Booth Street

Fire Safety Strategy

RIBA Stage 2

Doc ref: BST-HYD-XX-XX-RP-FE-0001

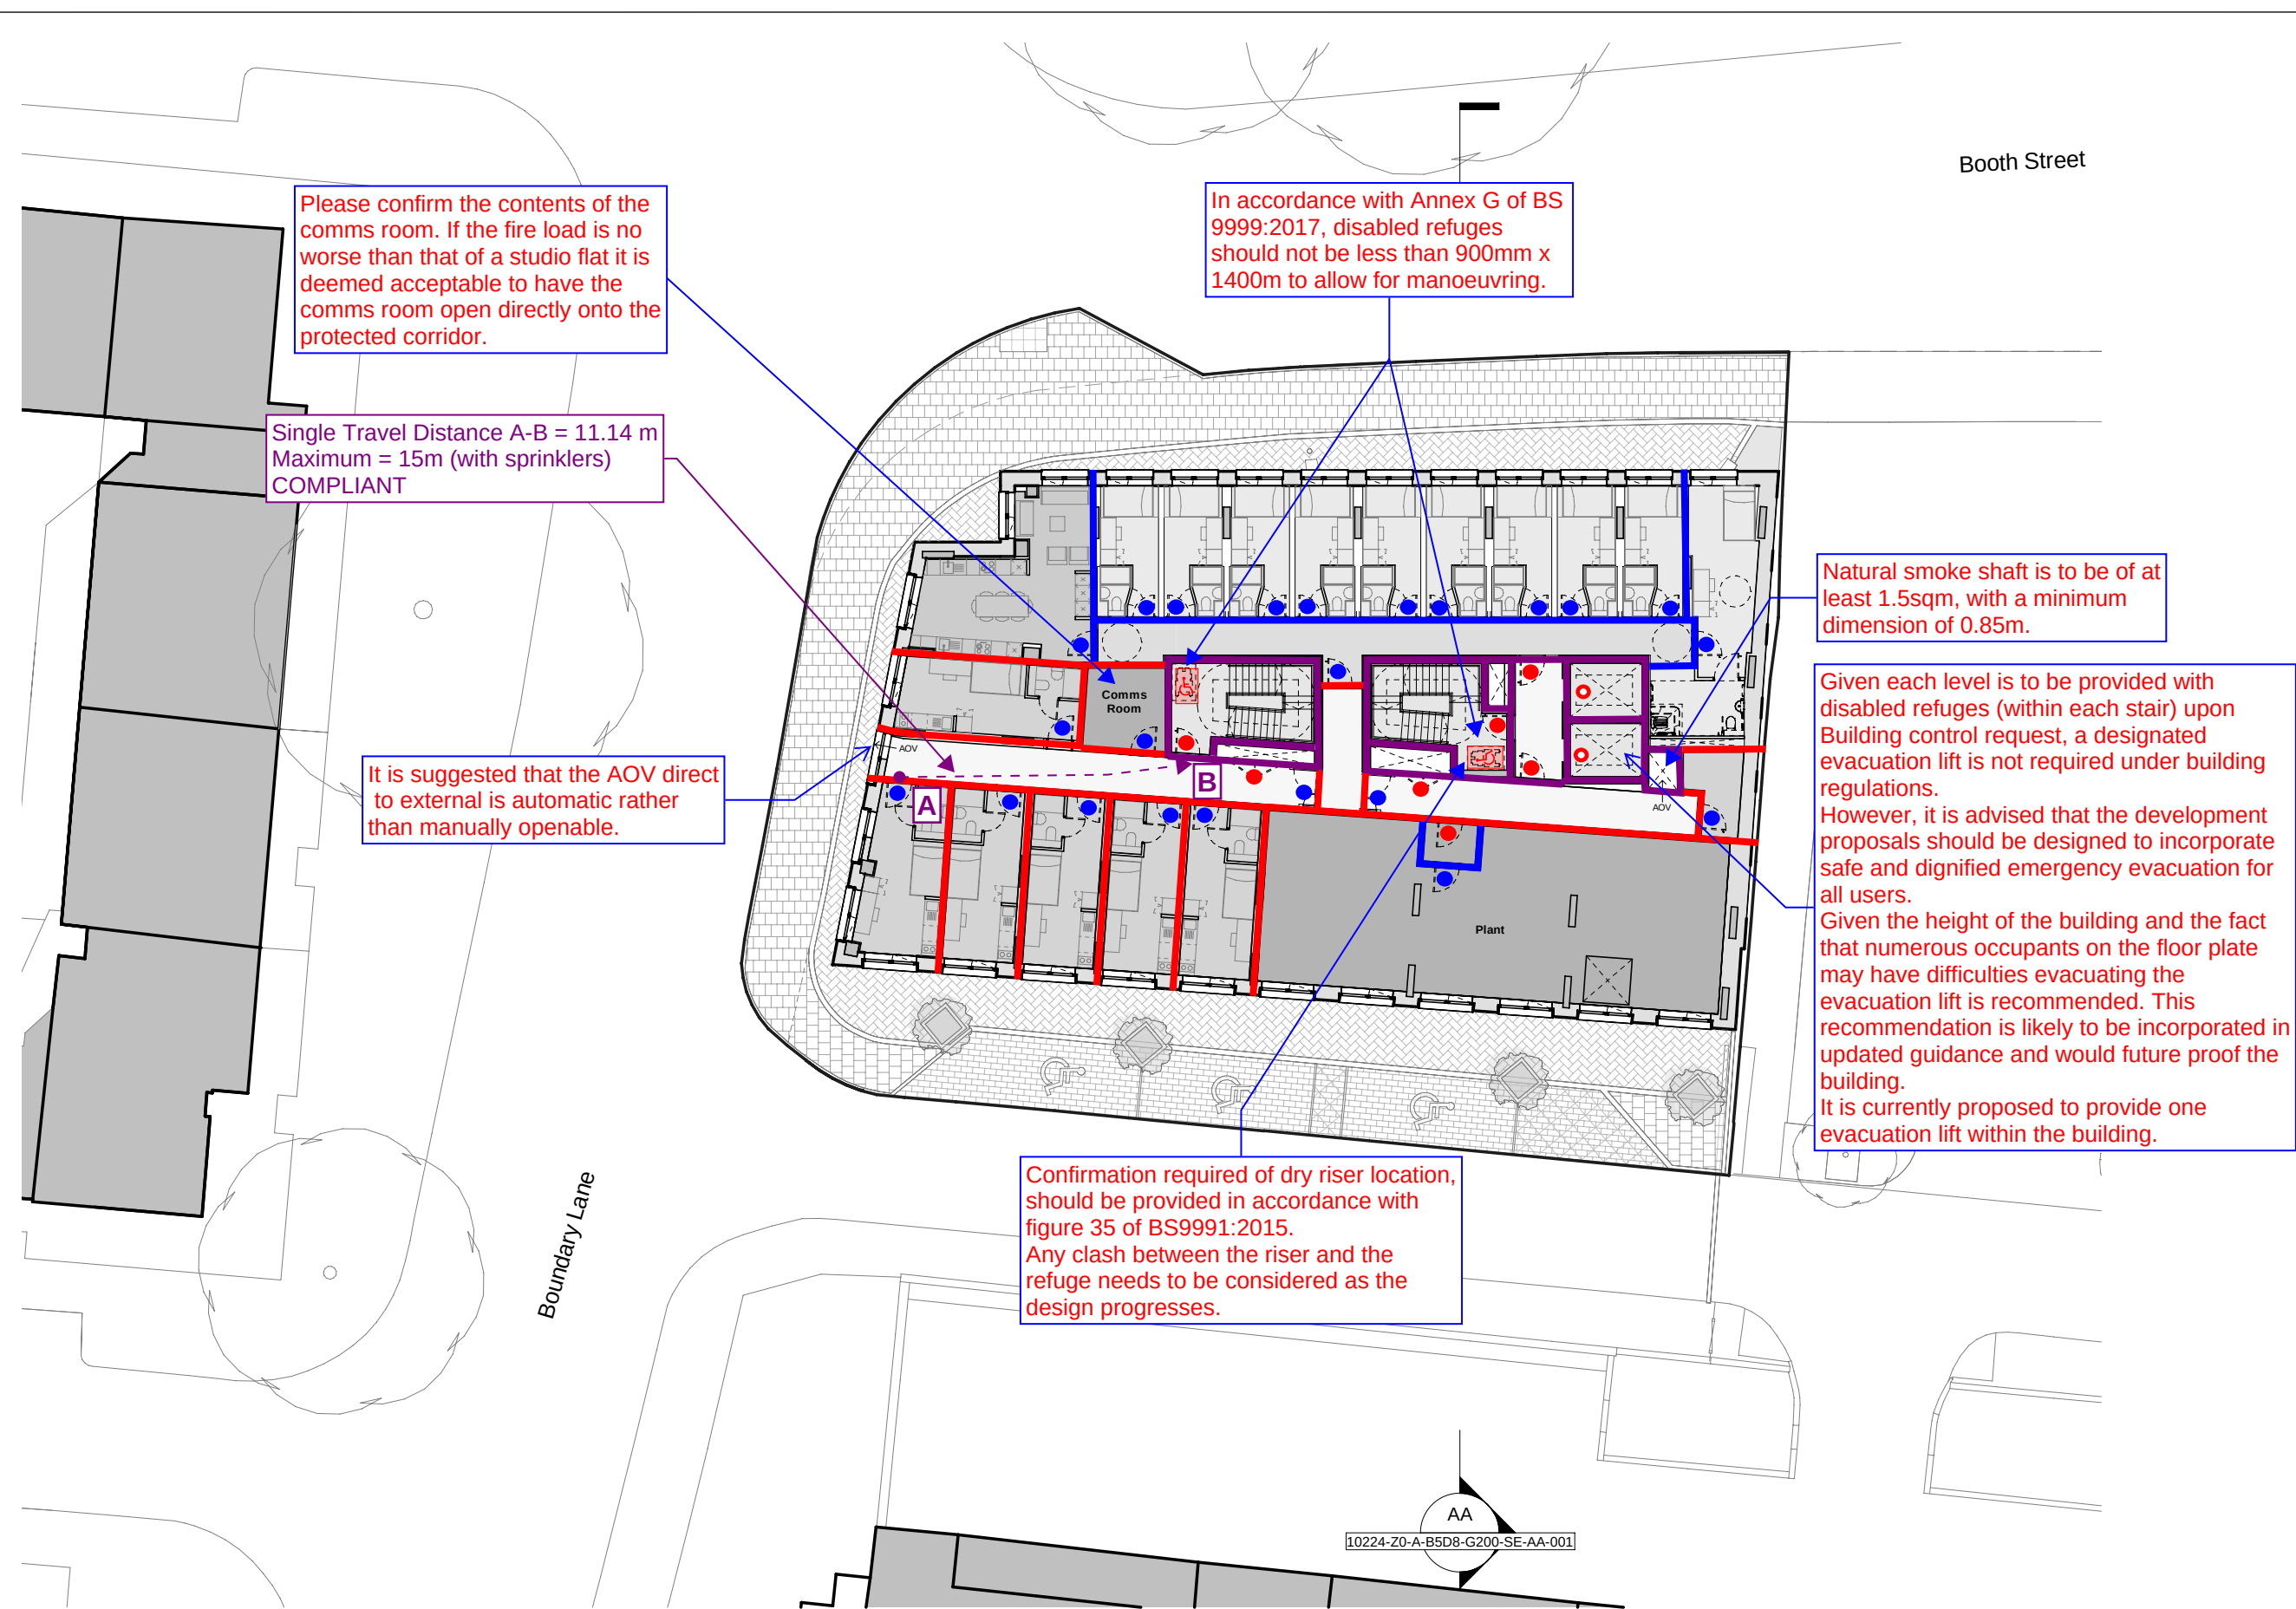
Note, non-residential ancillary areas exceeding the figures quoted in BS 9521:2021 table 4, then it is suggested a system designed in accordance with BS EN 12845 should be specified in this area. This is to be discussed and confirmed with the appointed M&E engineering and sprinkler specialist.

Community Hub, considered as a separate unit, to be separated from the remainder of the building by 120 minute fire resisting walls and floors.

Anticipated BS 9991 update requirement: Enclosure requirements of switch rooms in buildings above 30m has increased to 120 mins. Minimum requirement currently is 60 minutes

Given each level is to be provided with disabled refuges (within each stair) upon Building control request, a designated evacuation lift is not required under building regulations. However, it is advised that the development proposals should be designed to incorporate safe and dignified emergency evacuation for all users. Given the height of the building and the fact that numerous occupants on the floor plate may have difficulties evacuating the evacuation lift is recommended. This recommendation is likely to be incorporated in updated guidance and would future proof the building. It is currently proposed to provide one evacuation lift within the building.

In accordance with BS9991:2015, if a stair is providing access to ancillary accommodation, there should be a ventilated protected lobby or ventilated protected corridor at that level, the lobby ventilation should provide at least 0.4m2 permanent ventilation (or a suitable mechanical equivalent). Circulation space connection to stair discharge route.

This door is not providing additional protection and therefore could be removed.

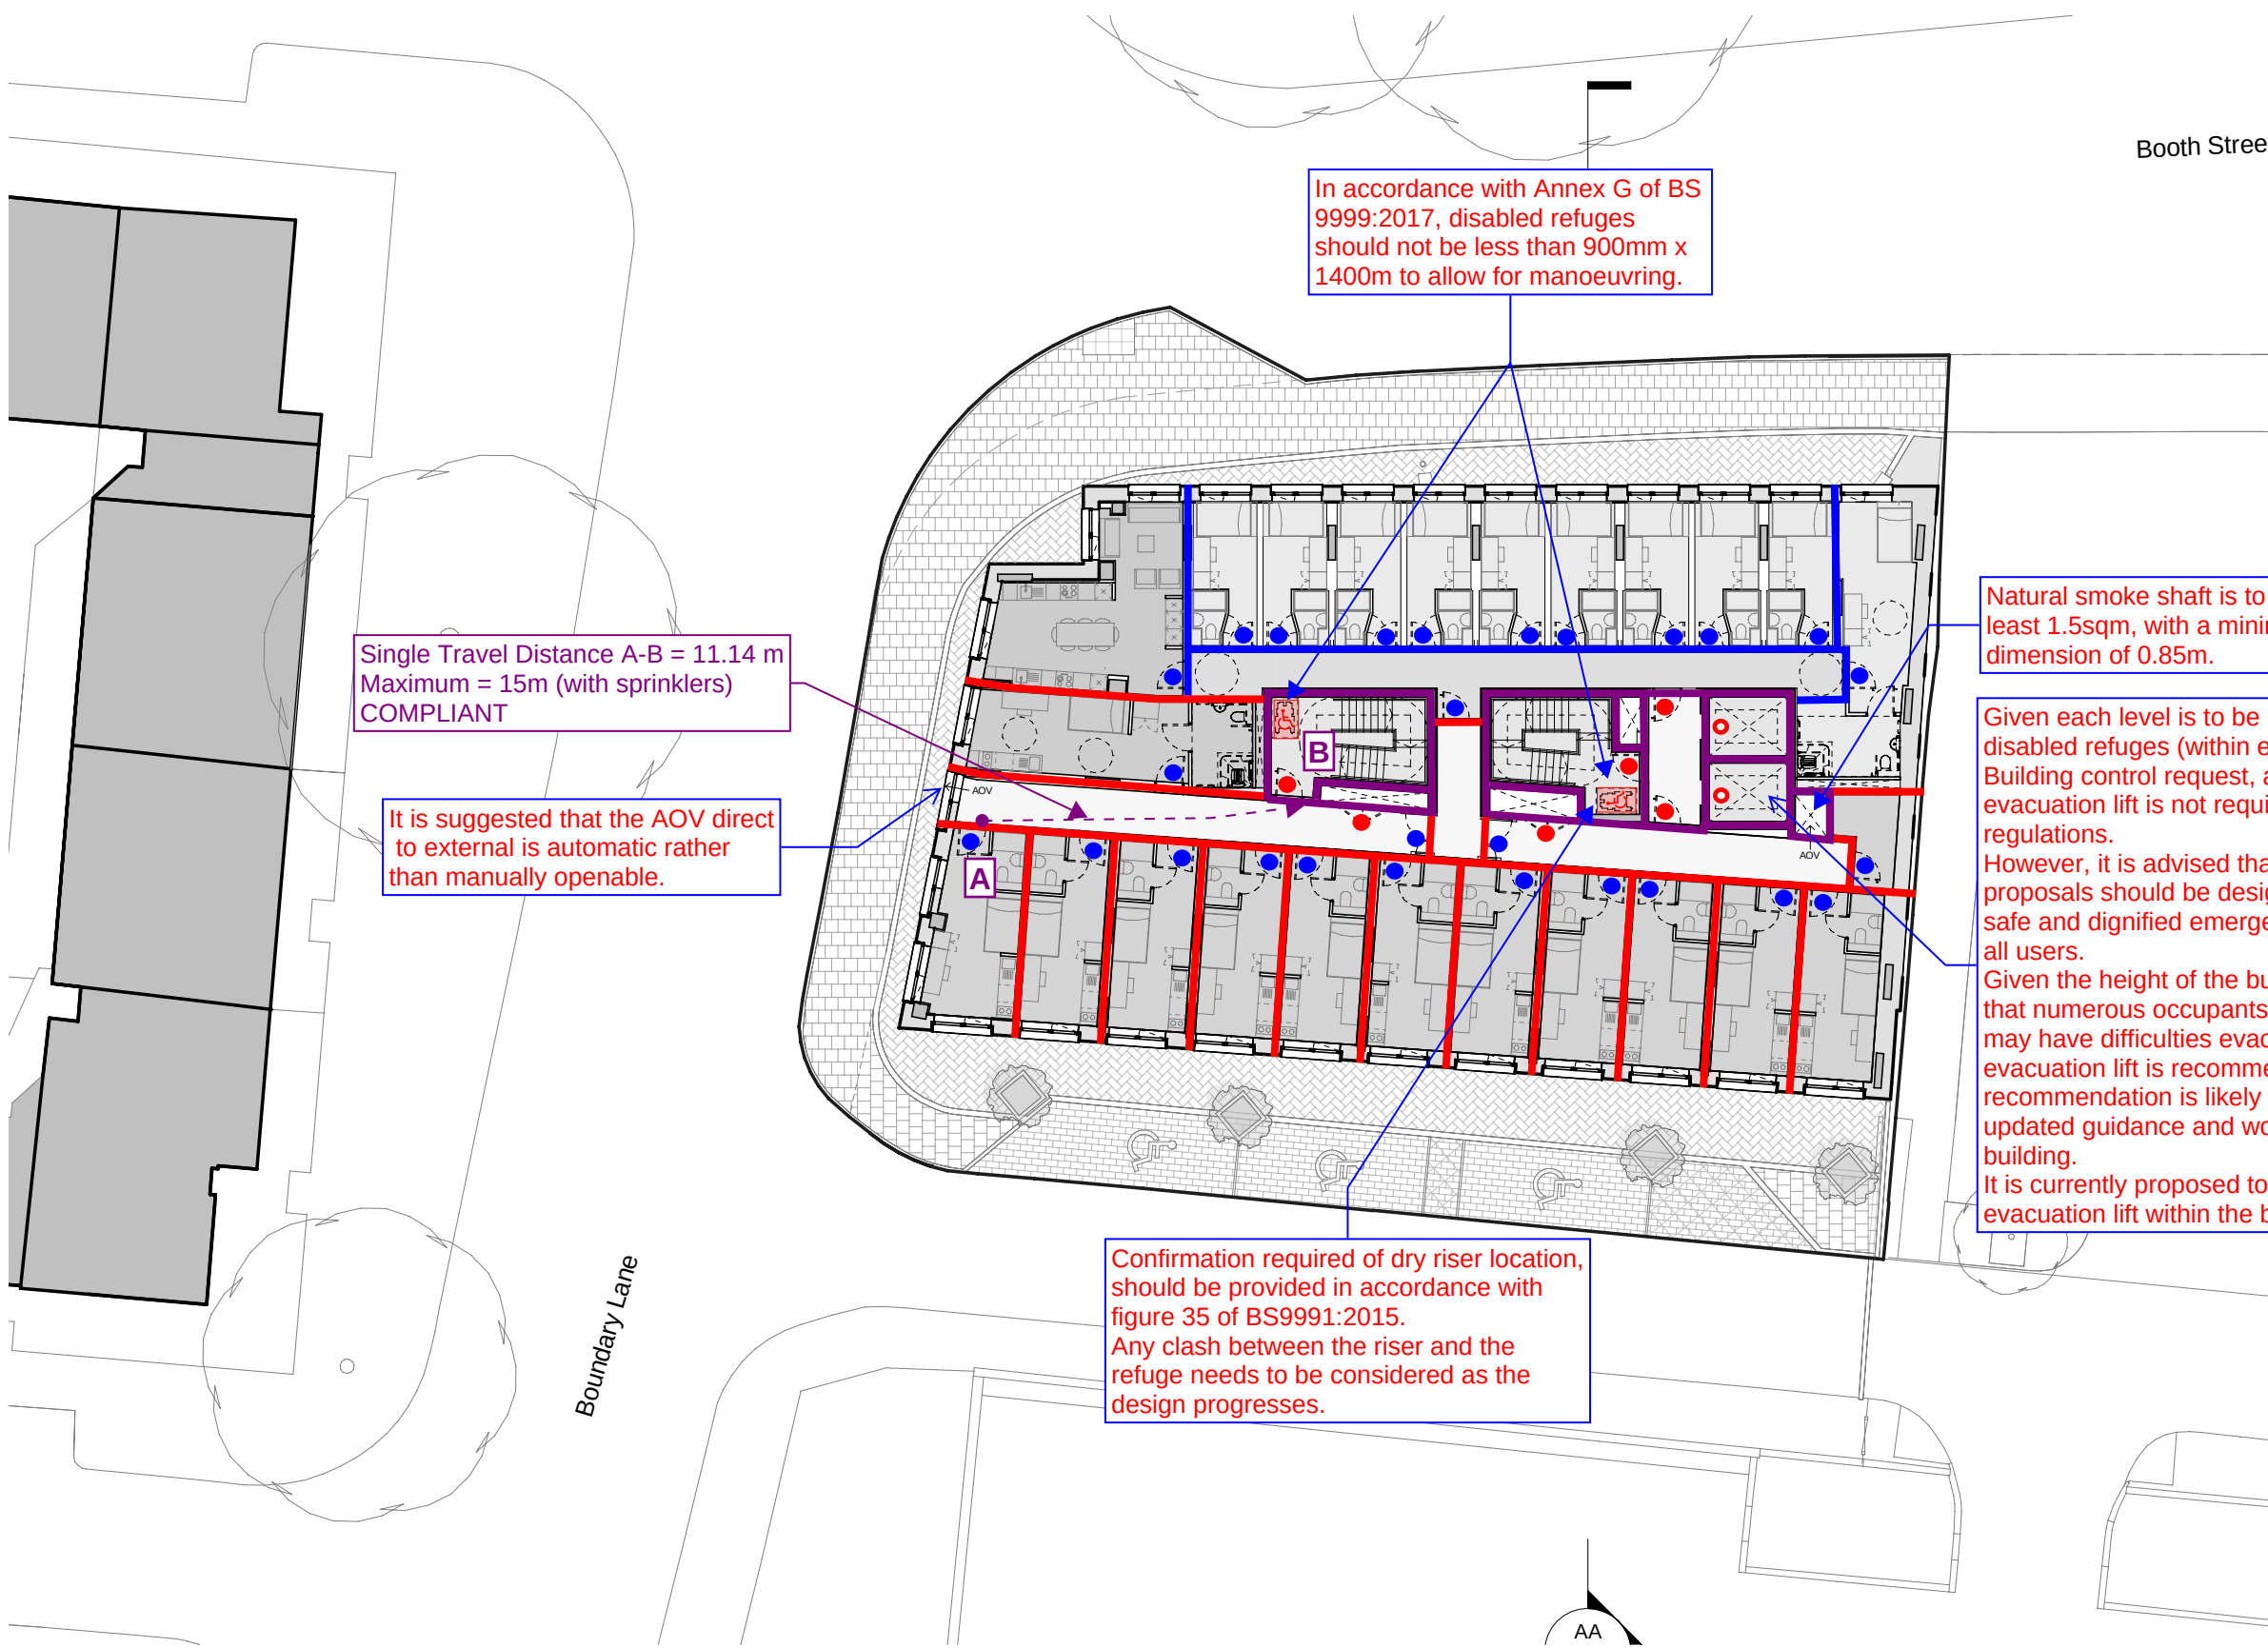
Single Travel Distance A-B = 11.14 m
Maximum = 15m (with sprinklers)
COMPLIANT

It is suggested that the AOV direct
to external is automatic rather
than manually openable.

In accordance with Annex G of BS
9999:2017, disabled refuges
should not be less than 900mm x
1400m to allow for manoeuvring.

Natural smoke shaft is to be of at
least 1.5sqm, with a minimum
dimension of 0.85m.

Given each level is to be provided with
disabled refuges (within each stair) upon
Building control request, a designated
evacuation lift is not required under building
regulations.
However, it is advised that the development
proposals should be designed to incorporate
safe and dignified emergency evacuation for
all users.
Given the height of the building and the fact
that numerous occupants on the floor plate
may have difficulties evacuating the
evacuation lift is recommended. This
recommendation is likely to be incorporated in
updated guidance and would future proof the
building.
It is currently proposed to provide one
evacuation lift within the building.

Confirmation required of dry riser location,
should be provided in accordance with
figure 35 of BS9991:2015.
Any clash between the riser and the
refuge needs to be considered as the
design progresses.
